**Sydney Metro: Chatswood to Sydenham (SSI-7400)
Approval of Artarmon Substation Station Design and Precinct Plan (SDPP)**

Station Design and Precinct Plan – Artarmon Substation

City & Southwest Chatswood to Sydenham project

Project:	Chatswood to Sydenham	Date:	14 May 2021
Group:	C&SW SEP	Status:	Final
Author:	Julieanne Boustead	Revision:	I
Company:	Systems Connect	File number:	SMCSWLWC-SYC-ATS-EM-PLN-003788
File name:	Station Design and Precinct Plan (SDPP) - Artarmon Substation

Figure 4: Plan Artarmon Substation, Barton Rd, Chatswood-Sydenham May-June 2016 EIS summary

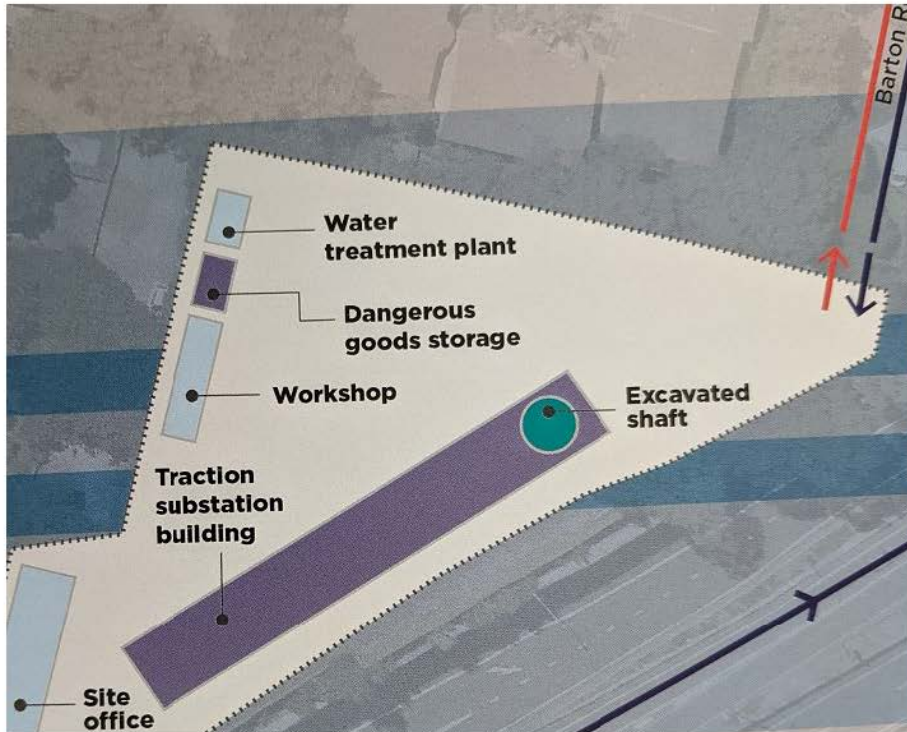
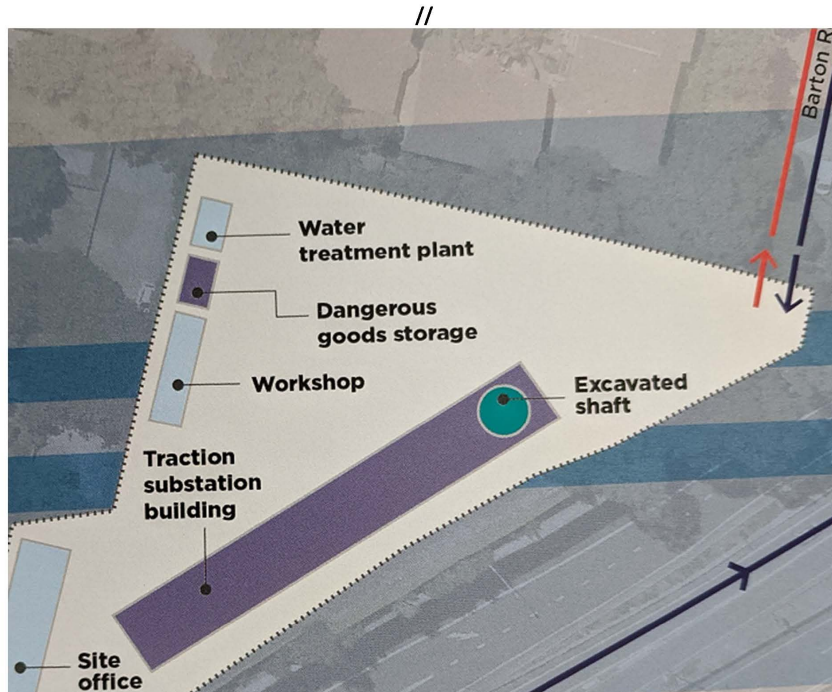
It is also out of character with the images of the Substation as depicted in the Chatswood to Sydneyham May-June 2016 EIS Summary (Figures 4 and 5). These figures show a well-designed single building with a sparse fence that cannot be used as a graffiti billboard.

It is also out of character with the images of the substation as depicted in the Chatswood to Sydenham May-June 2016 Environmental Impact Statement Summary (EIS) (Figures 4 and 5). These figures show a well-designed single building with a sparse fence that cannot be used as a graffiti billboard.

Figure 6 – Western Harbour Tunnel and Warringah Freeway Upgrade March 2020

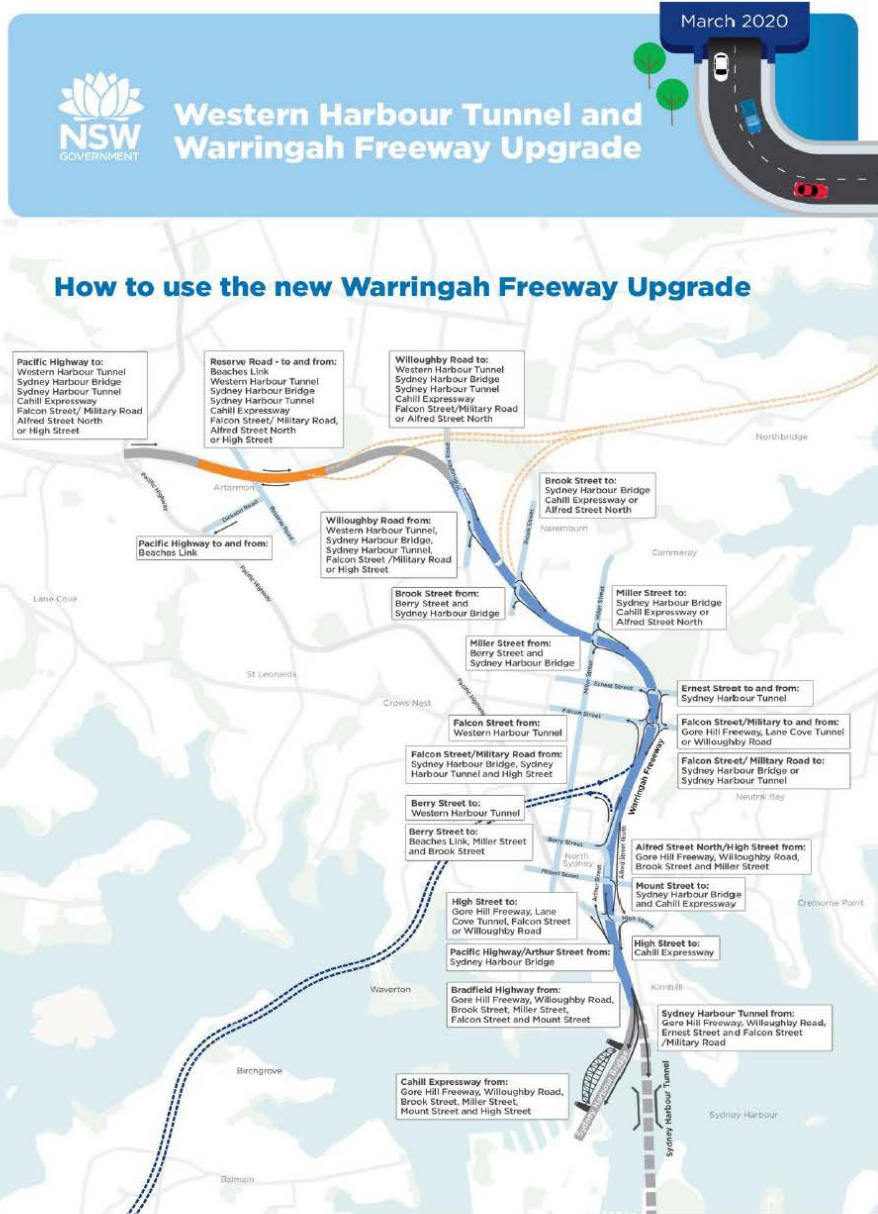
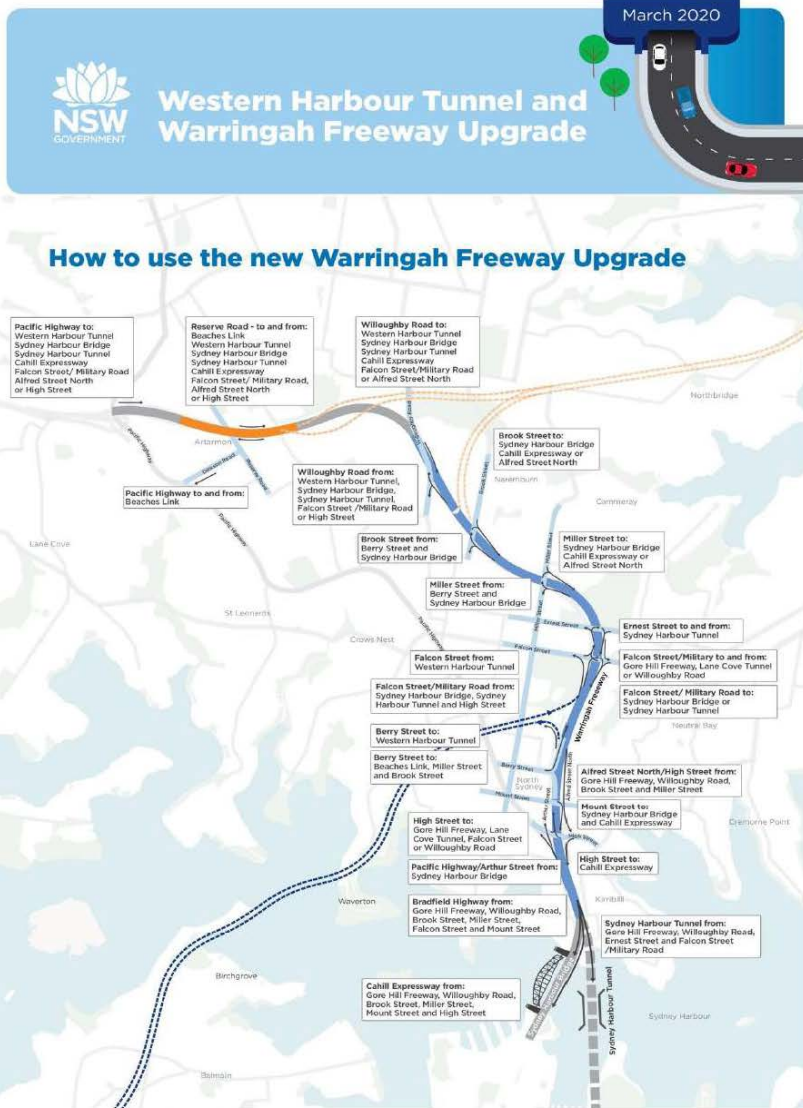
The SDPP was completed 30 April 2017, three years before the "Western Harbour Tunnel and Warringah Freeway Upgrade March 2020" illustration (Figure 6) was released by TfNSW.

The Station Design and Precinct Plan (SDPP) was completed on 30 April 2017, three years before the "Western Harbour Tunnel and Warringah Freeway Upgrade March 2020" illustration (Figure 6) was released by TfNSW.

Figure 7 – Reserve Road widening for Beaches Link project

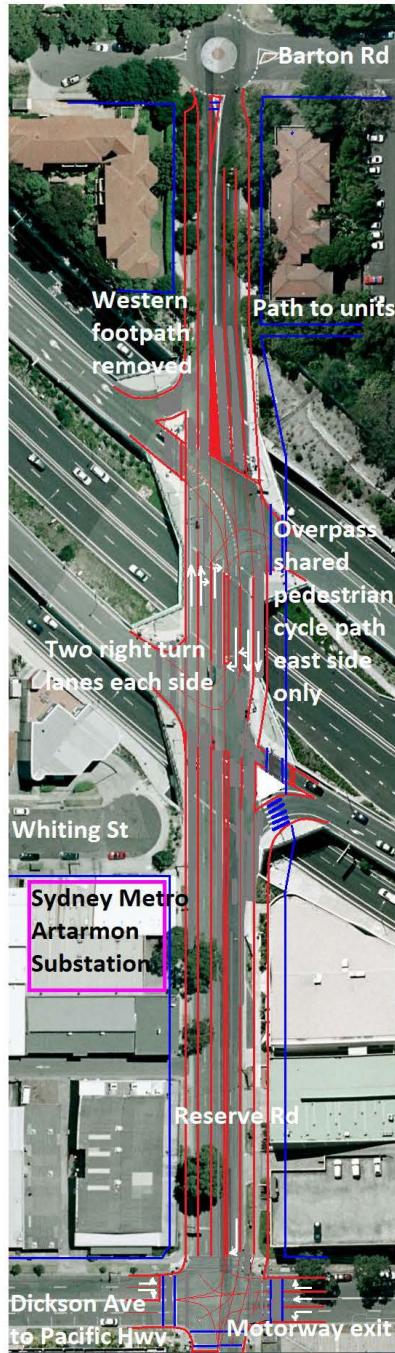
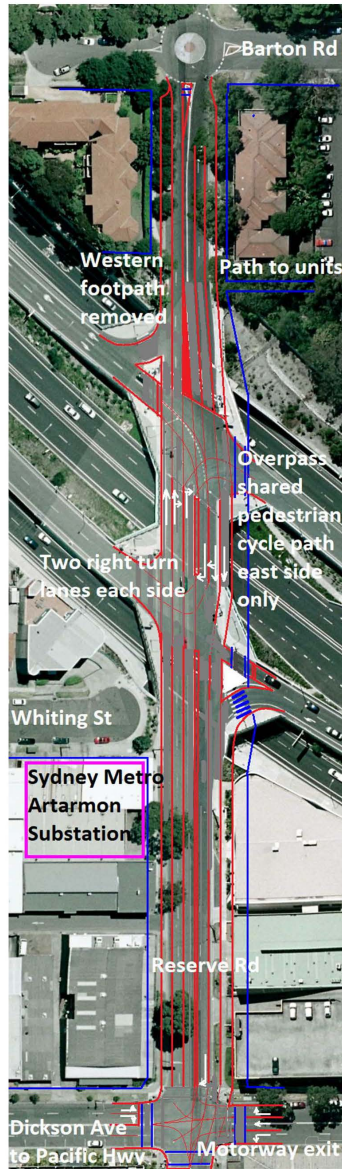
The westward shift of the roadway by 1.8 m needs to apply between Barton Rd and Dickson Ave due motorway ramp layout, Reserve Rd congestion, and the current poor Level of Service rating of 'F' for the Barton Rd and Dickson Ave intersections. Figure 7 provides an illustration of the likely layout of reserve Rd between Dickson Ave and Barton Rd.

The westward shift of the Reserve Rd roadway by 1.8 m needs to apply between Barton Rd and Dickson Ave due to the motorway ramp layout, Reserve Rd congestion, and the current poor Level of Service rating of 'F' for the Barton Rd and Dickson Ave intersections. Figure 7 provides an illustration of the likely layout of Reserve Rd between Dickson Ave and Barton Rd.
